**RESTROOM RENOVATIONS AT CITY HALL  
ITB-24-02**

**ADDENDUM NO. 2**

**April 11, 2024**

# A211

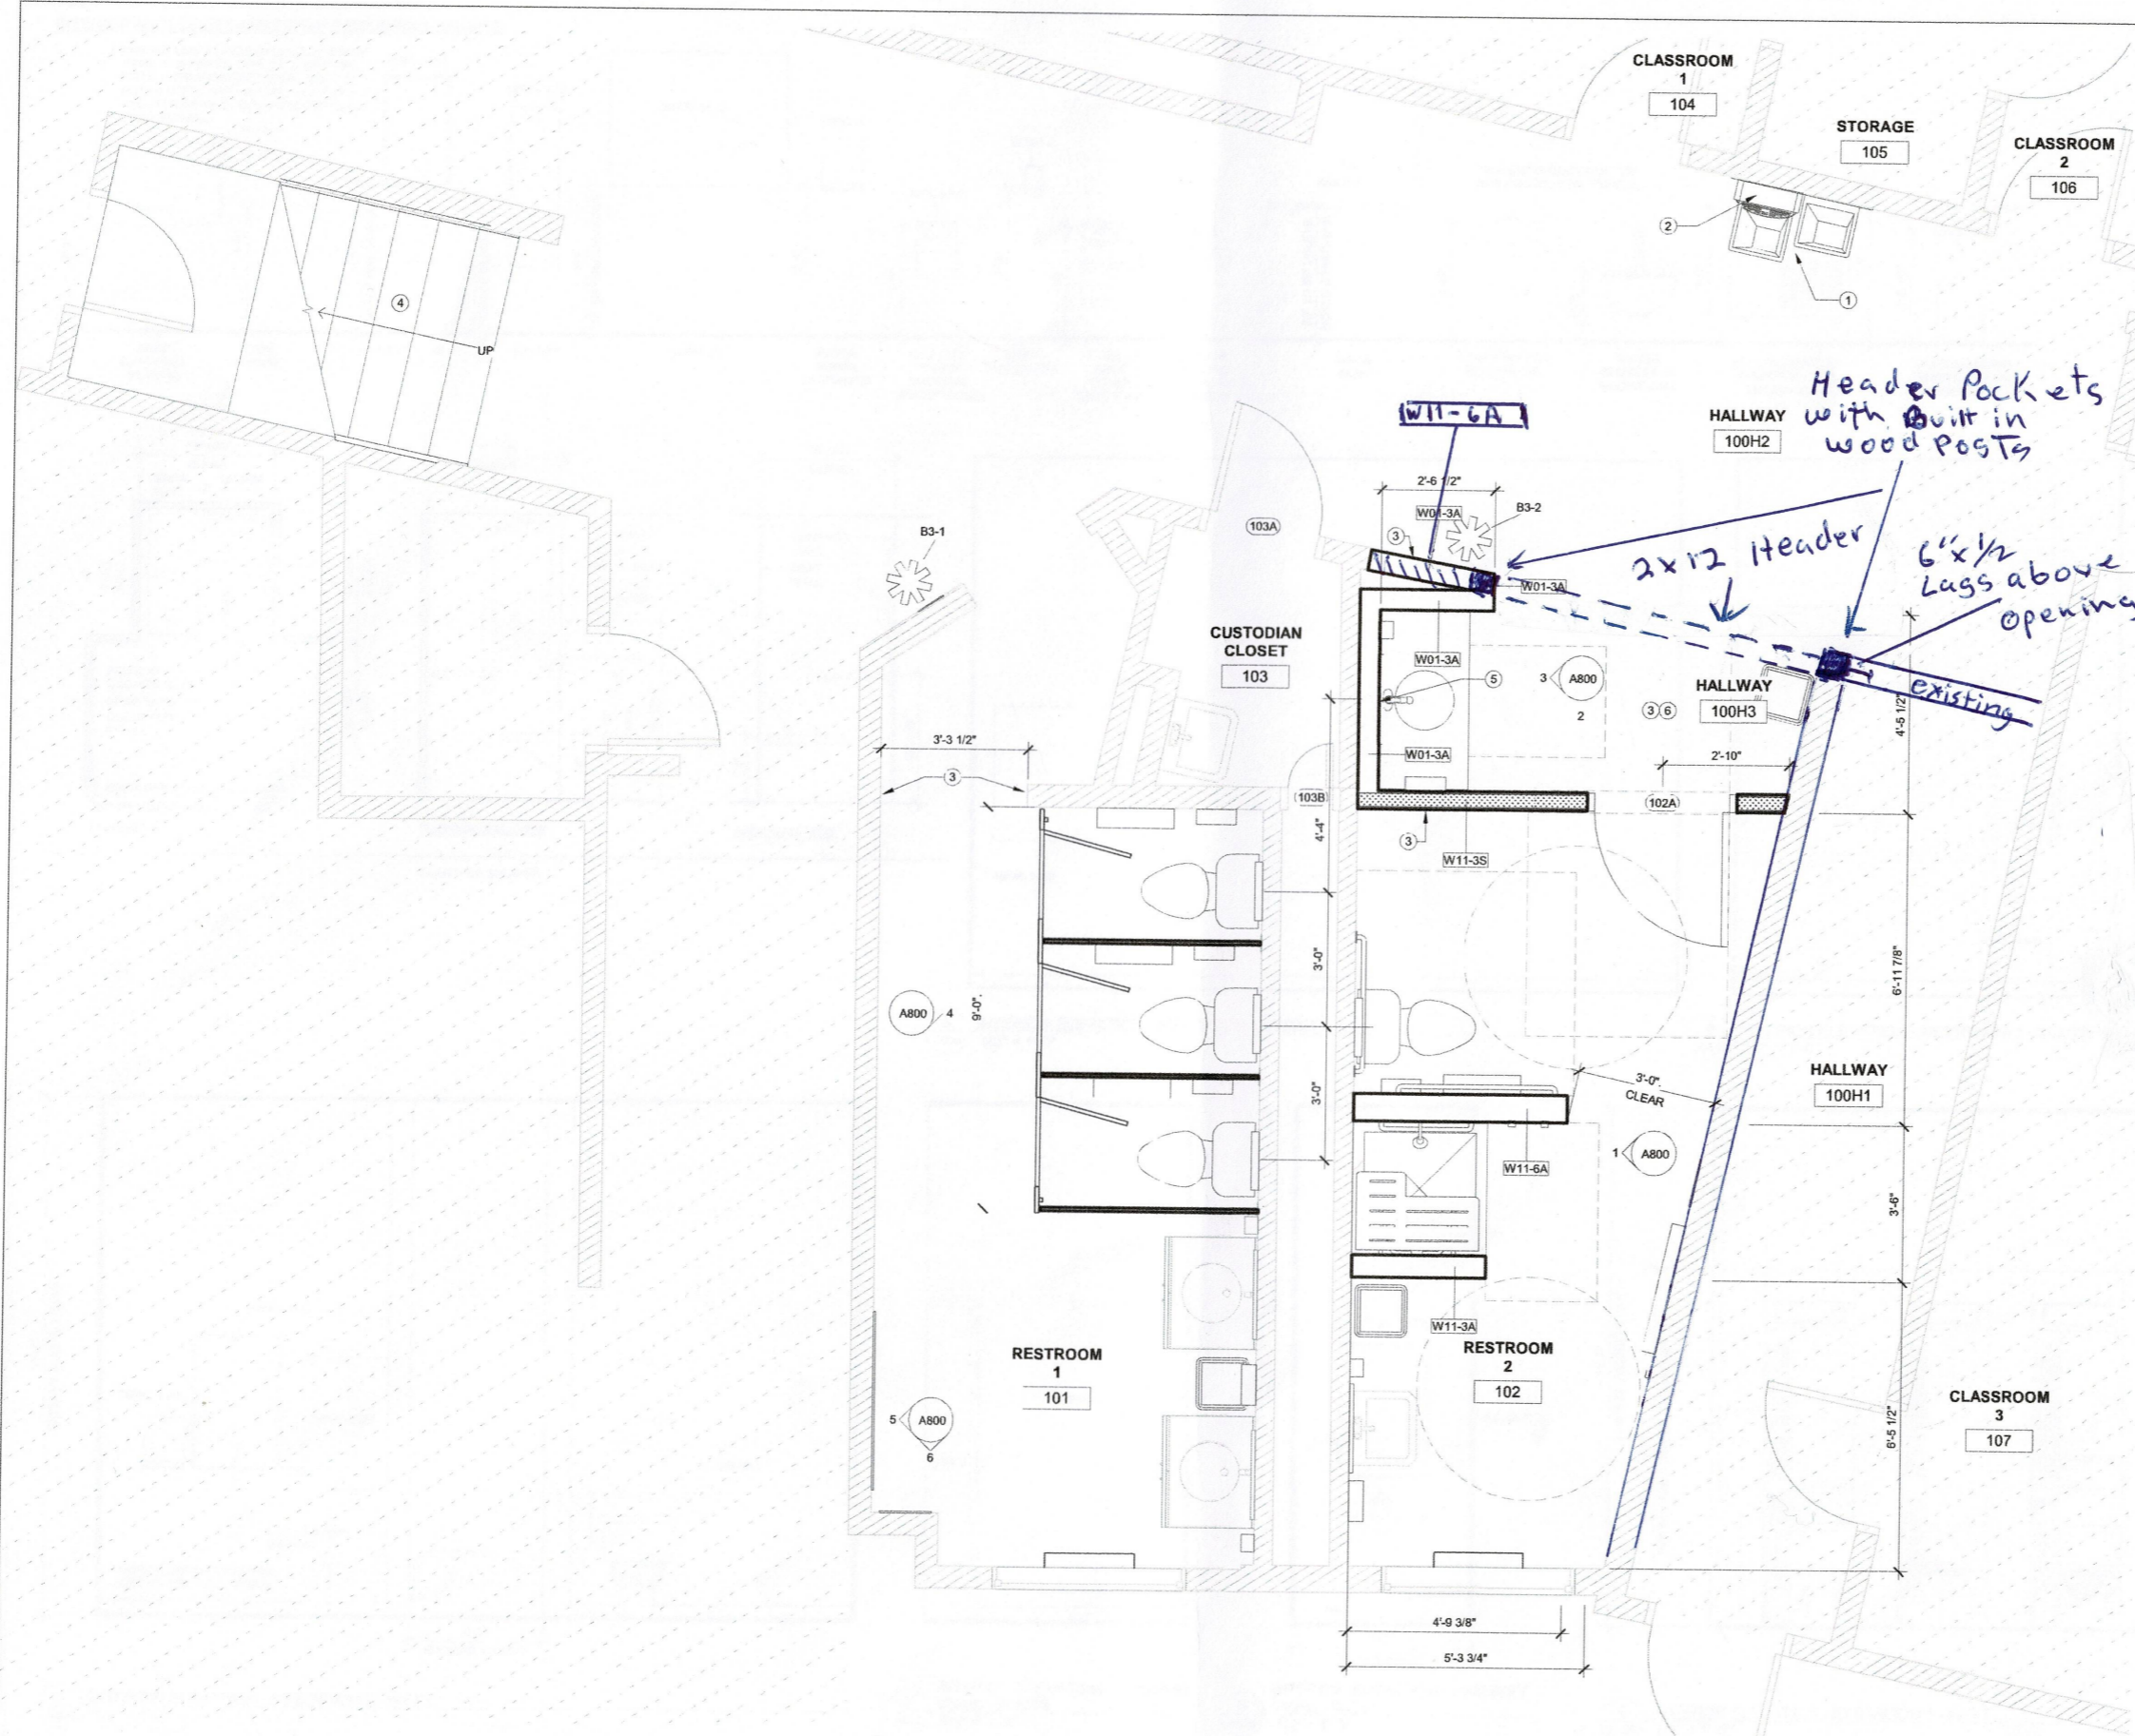
1. See attached contractor questions (1 through 20) and City of Fairbanks Responses.
2. See attached A211 Mark-up for wall support conceptual design.

<u>Contractor Questions</u>	<u>Responses</u>
1	When partial demo of outer wall of Restroom 2 is completed how will the remaining portion of the wall be supported?	Demolish wall to a height necessary to meet the design specifications; finished wall should be designed to provide structural support and visual aesthetics. This could include a vertical post and new headers if necessary. See sheet A211 mark-up provided with Addendum 2 for a design conceptual sketch that would be acceptable in achieving the stated goals.
2	Is the Contractor to provide electrical load calculations for panel GD10 which will serve the new water heater?	Yes.
3	Please clarify the type and manufacture of light fixture called out on A211/Note 4 is acceptable to be installed in Hallway 100H1	Yes. Proceed as designed.
4	Please confirm stairway on A211/Note 4 is to have (2) each, 2ft long light fixtures installed at the top and bottom of stairwell.	No. Proceed as designed.
